Access Compliance Report

Public Rights-of-Way

(Curb Ramps)

Intersection ID: 13715	Main Street: E_MOREHEAD_ST	Cross Street: ROYAL_CT	Location: N
ADA ID: 2FE5EA1CCF31	Ramp Type: PerpDiag	Initial Pass/Fail: Fail	Overall Compliance: No
Severity Score: 13.75			
Codes/Mitigation Info/Possible Solution		Field Measurements/Component Compliance

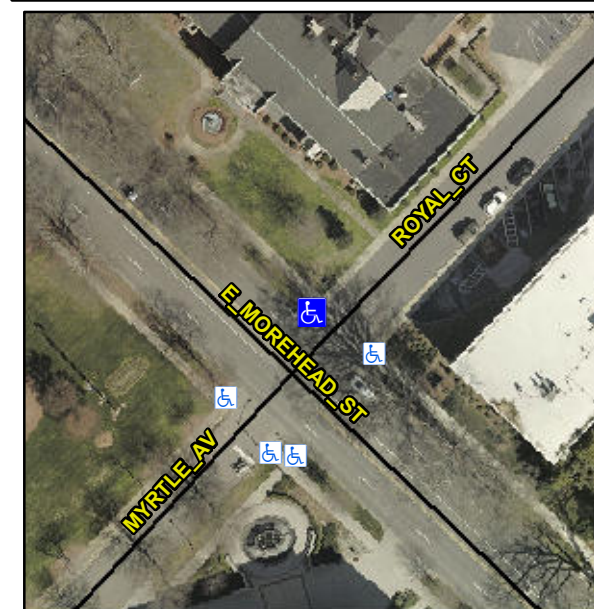
Not Found, R304.2.2, R304.5.3

Compliance	Description	Data	Compliance	Description	Data
N/A	Ramp Length (in)	66.0	No	Ramp Slope (%)	9.2
Yes	Ramp Width (in)	48.0	No	Ramp XSlope (%)	2.9
N/A	Flare Type LT	N/A	N/A	Flare Type RT	N/A
N/A	Flare Slope LT (%)	N/A	N/A	Flare Slope RT (%)	N/A
N/A	Flare Traversable LT?	N/A	N/A	Flare Traversable RT?	N/A
N/A	Landing Length (in)	N/A	N/A	DWS Provided?	N/A
N/A	Landing Width (in)	N/A	N/A	DWS Contrast?	N/A
N/A	Landing Slope (%)	N/A	N/A	DWS Length (in)	N/A
N/A	Landing X Slope (%)	N/A	N/A	DWS Full Width?	N/A
N/A	Landing Curb? (Y/N)	N/A	N/A	DWS Offset (in)	N/A
N/A	Shared Landing?	N/A			
N/A	Gutter Ponding?	N/A	N/A	Gutter Slope (%)	N/A
N/A	Gutter Lip Ht (in)	N/A	N/A	Gutter X Slope (%)	N/A
N/A	Painted X Walk1?	No	N/A	Painted X Walk2?	No
	X Walk 1 Direction	To SW		X Walk 2 Direction	To SE
N/A	X Walk 1 Width (in)	N/A	N/A	X Walk 2 Width (in)	N/A
	X Walk 1 Slope (%)	6.0		X Walk 2 Slope (%)	0.7
	X Walk 1 X Slope (%)	0.1		X Walk 2 X Slope (%)	0.9

Remove & Replace Curb Ramp With Two New Directional Ramps or Equivalent.
